SAMARKAND

Design zone — base plan (existing conditions)

254 Võ Nguyên Giáp, P. Phước Mỹ, Q. Sơn Trà, Đà Nẵng

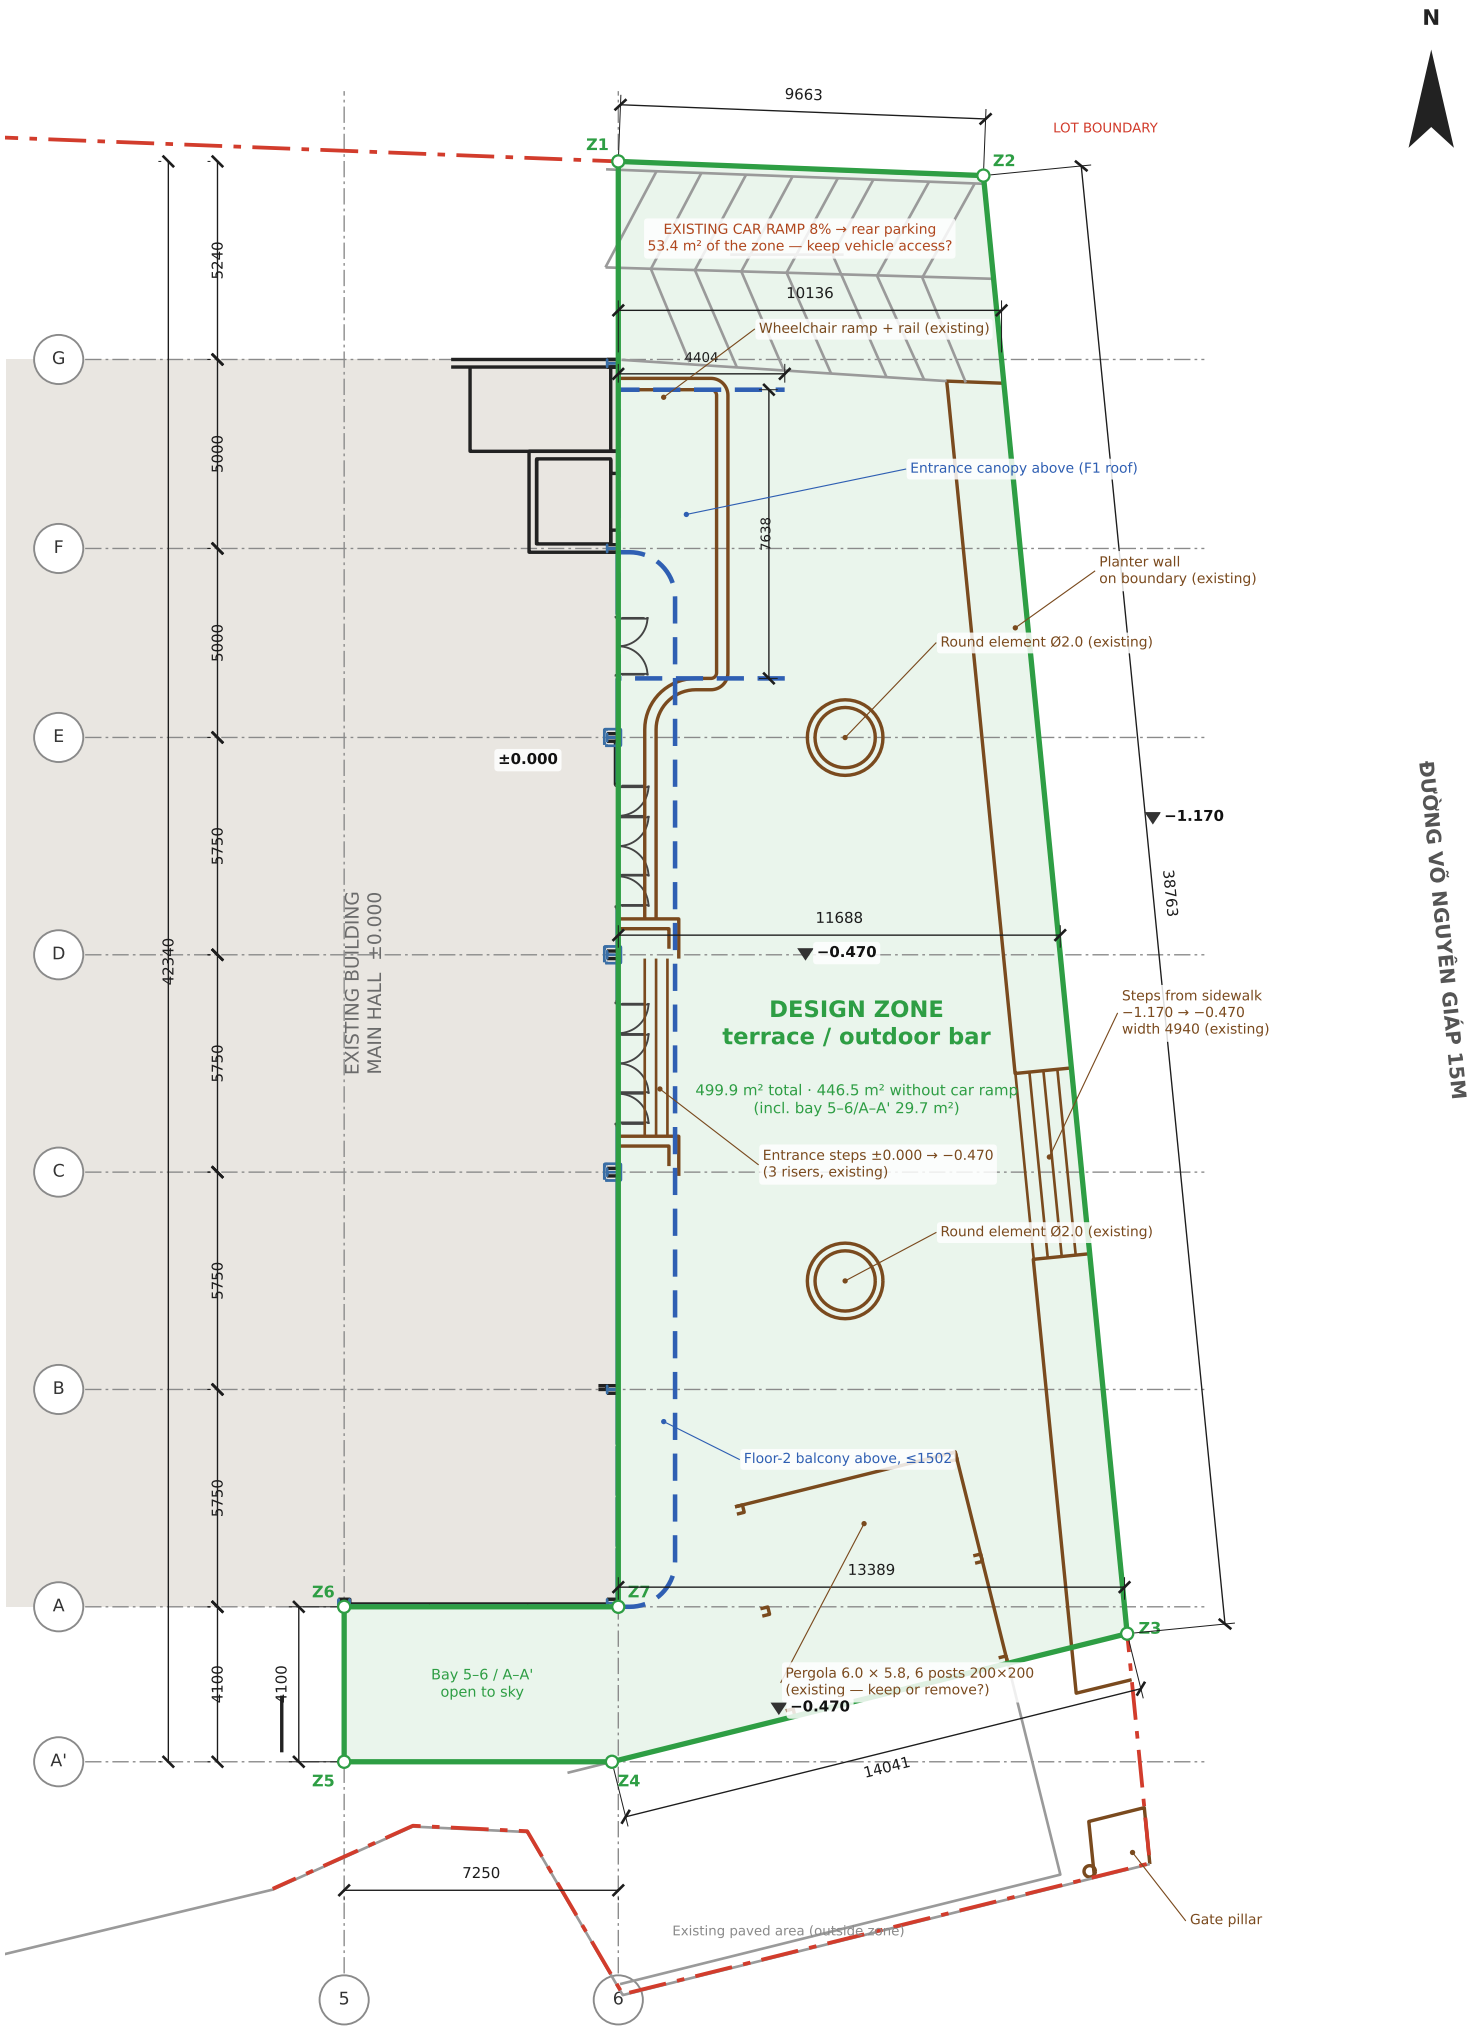
VERIFY ON SITE BEFORE DESIGN FREEZE

1. Entrance canopy: F1 plan 4404 × 7638, site plan shows 5000 × 9200 — measure.
2. Floor-2 balcony edge (≤1502 from façade) — confirm soffit height.
3. Two round elements Ø2.0 — what are they (planter / fountain / tree)?
4. Pergola 6.0 × 5.8: west side open in DWG — keep, rebuild or remove?
5. Bay 5–6 / A–A': open to sky in F2 plan; F3 / roof not checked.
6. Levels from DWG: ±0.000 hall, −0.470 forecourt, −1.170 sidewalk.
7. Drainage, power, water points in the zone are not in the DWG.
8. North strip Z1–Z2 is the 8% car ramp to parking: keep, or relocate access?
